**1400 North at 600 West
Intersection Improvement Project
Questions and Answers
10/24/2019**

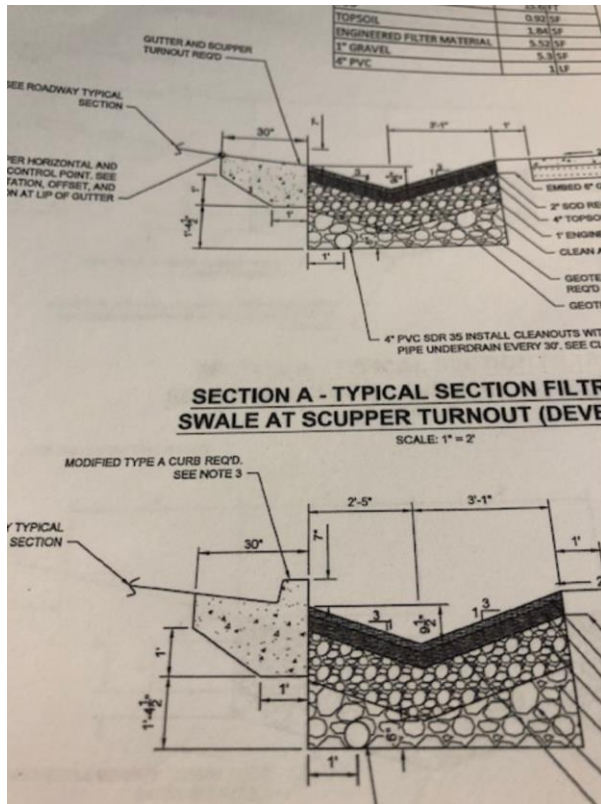
Can this curb be squared off on the bottom on sheet DD-1

The curb at the swales is allowed to be squared off as long as the depth of curb extending below the top of the upper swale edge is equal to or greater than the depth shown in the details. The front face of the curb (facing the roadway/asphalt) shall be formed vertical for its entire depth. Cost for extra formwork and for additional concrete shall be borne by the contractor.
